INFORMATION SHEET 10/13/15 TRUSTEES MEETING

ISSUE: RGM Associates Jefferson Change Order #'s and Traina Gymnasium Change Order #'s #021, #029-R1 and #030

RE: Anthony Traina Gym and Performance Center
DSA Appl. #: 02-113192
COR #021

APPLICATION FOR APPROVAL OF CONSTRUCTION CHANGE DOCUMENT - CCD CATEGORY A

SKC -1

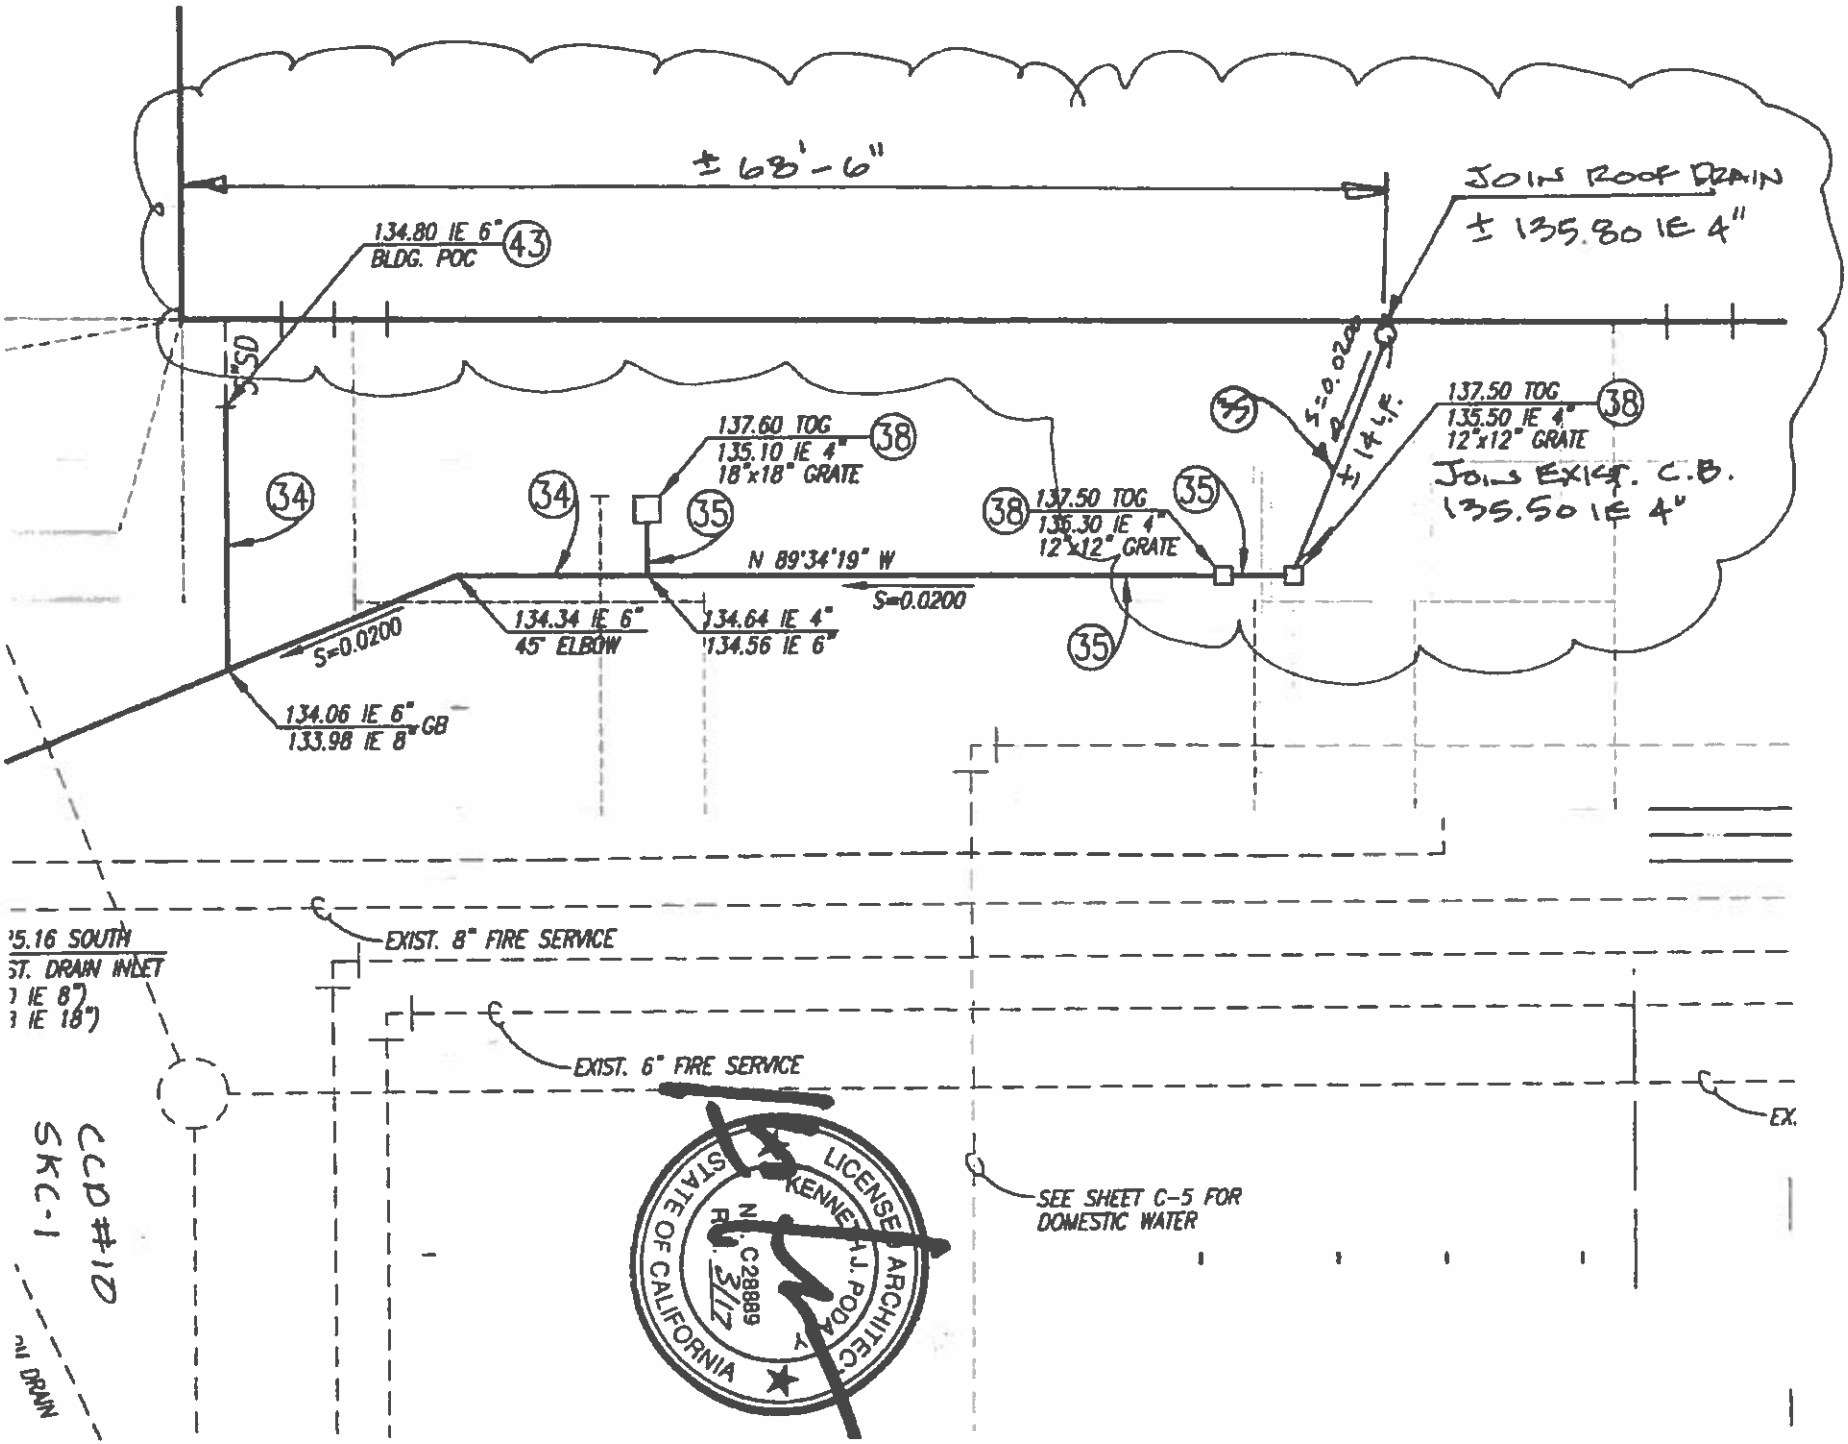
Provide new storm drain connection per SKC-1. Revise the roof crickets from wood framed to rigid insulation and replace roof drains with collector box and downspouts per SKA-1 through SKA-5 . Add two additional roof drains and revise the storm drain connections per P-1 through P-8.

SKA-1

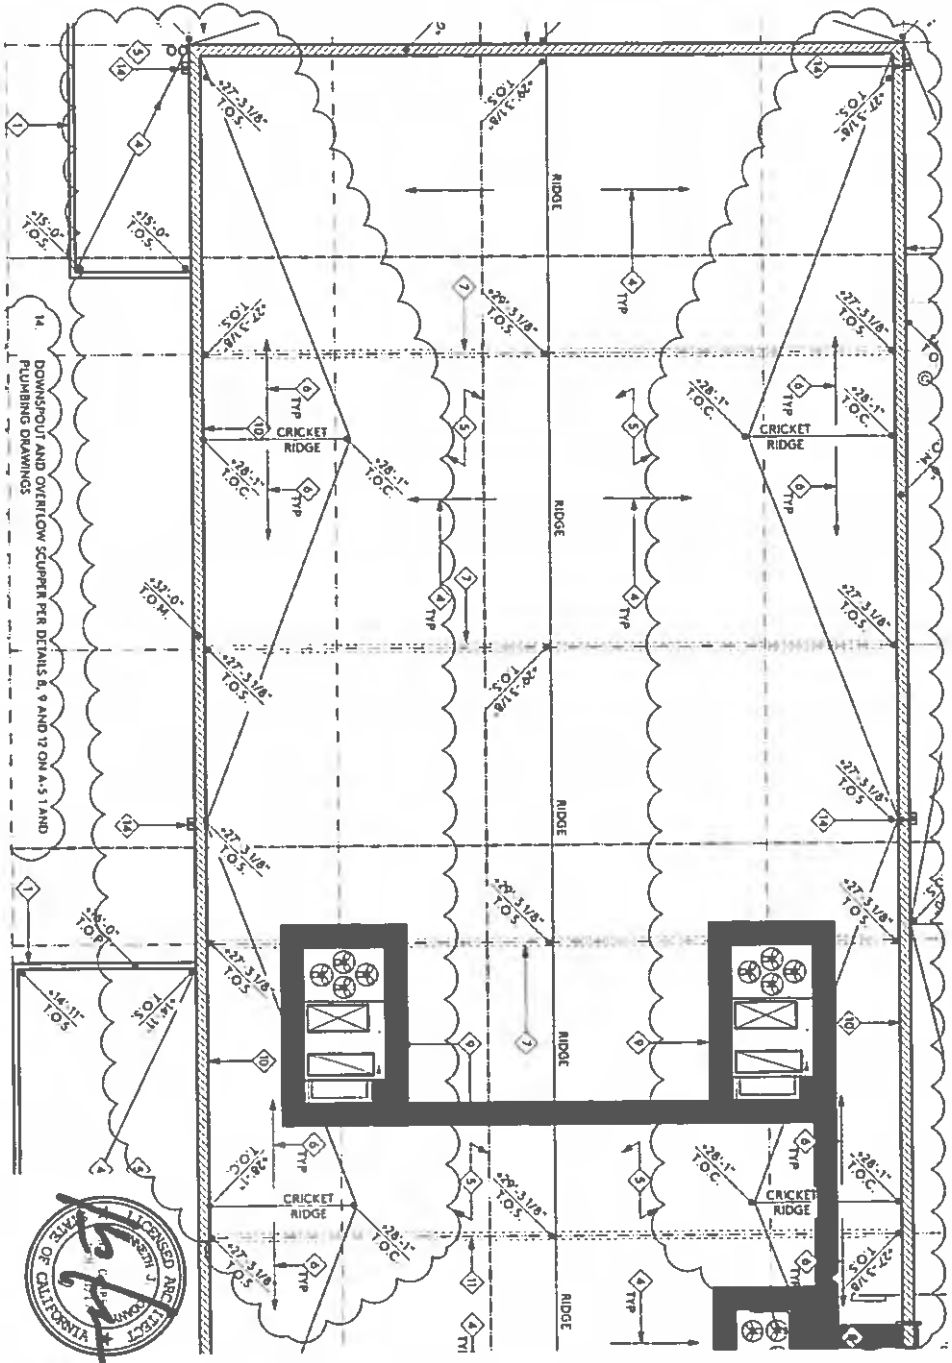
Notes: To replace roof drains with downspouts per detail SKA-1 through SKA-5, SKA-2 detail #8 & SKP-8. Add two additional roof drains and revise the storm drain connections.
